In the United States Patent and Trademark Office

For: Self-Route Expandable Multi-Memory Packet Switch with Distributed Scheduling Means

Serial Number: 09/683,429

Response and Amendment Under 37 C.F.R. §1.111

FIG. 3

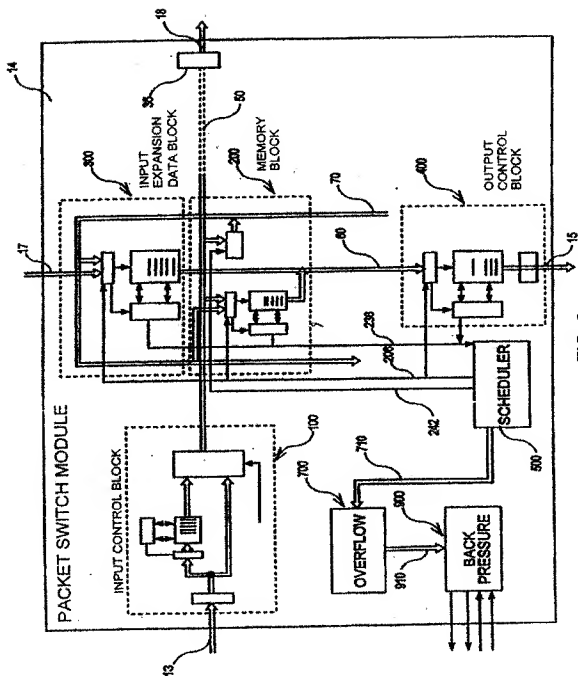
The Office Action stated an objection to Figures 3-8 as failing to comply with 37 CFR 1.121(d) because descriptive labels necessary for understanding the drawings are missing. The Office Action also stated that the quality of the connections shown on Figure 8 is not acceptable. A proposed set of drawings to overcome the objections is attached to this amendment as Appendix A. Each sheet has been labeled "Replacement Sheet" to be in compliance with 37 CFR 1.121(d).

The Office Action stated that claims 1-14 are rejected under 35 U.S.C. 112, second paragraph as being indefinite for failing to particularly point out and distinctly claim the subject matter which applicant regards as his invention. Specifically, for Claim 1, the Office Action stated that it was unclear as to what output and input ports are considered a pair and what is the definition of a cross point. Applicants submit that the definition of “cross point” is defined in paragraph 10 of the specification as “each couple of an input port and an output port defining a cross point within the switch module” and is shown in Figures 1, 3, 5, and 8. In Figure 1, the input and output ports are shown as the input buses 13_1 – 13_4 and corresponding output busses 15_1 – 15_4 coupled

to the packet switch module 14. A pair is therefore any one of the input ports (i.e. input bus 13) coupled to any one of the output ports (i.e. output bus 15). For example, one cross point is input bus 13_1 coupled to output bus 15_4, or input bus 13_2 coupled to output bus 15_3, etc. Thus, for 4 input ports and 4 output ports there is a total of 16 cross points. In Figure 3 the cross point is shown as the intersection of elements 50 and 60, which are coupled to data bus in 13 and data bus out 15 respectively (see paragraph 27). Memory Block 200 is associated with the cross point shown in Figure 3. Figure 5 shows a block diagram of Memory Block 200 with the intersection of elements 50 and 60 showing the cross point. Figure 8 shows multiple cross points for input ports 13_1 – 13_m and output ports 15_1 – 15_m and represents an mxm number of cross points with associated memory blocks 200 for each cross point.

each memory block associated with one of said cross points ...”. Support for Applicants’ claim 1, as amended, can be found, for example, in paragraph 0025 and Figure 3.

FIG. 8

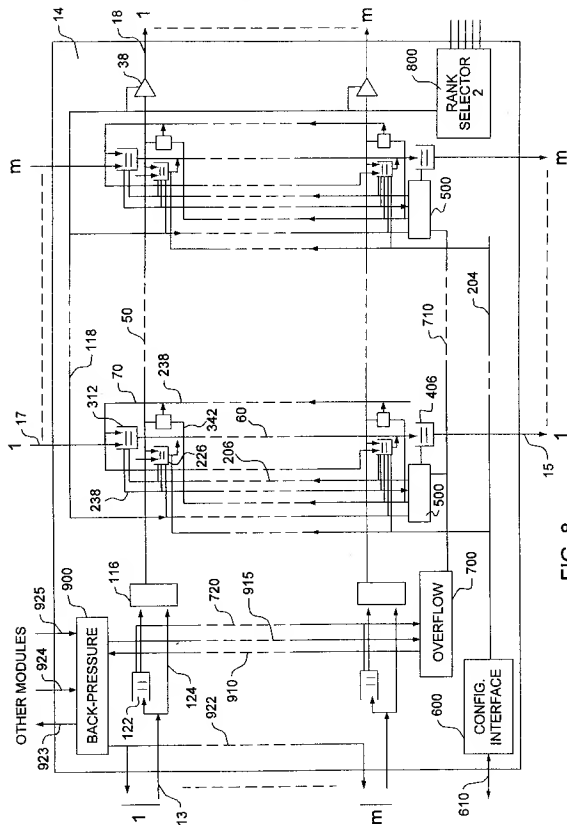
Applicants respectfully submit that Yamazaki does not teach or suggest the limitation of Applicants’ claim 1, as amended, of “...a plurality of schedulers, each scheduler associated with one of said output ports ...”. Support for Applicants’ claim 1, as amended, can be found, for example, in paragraphs 0008, 0026, 0051, 0052 and Figures 3 and 8.
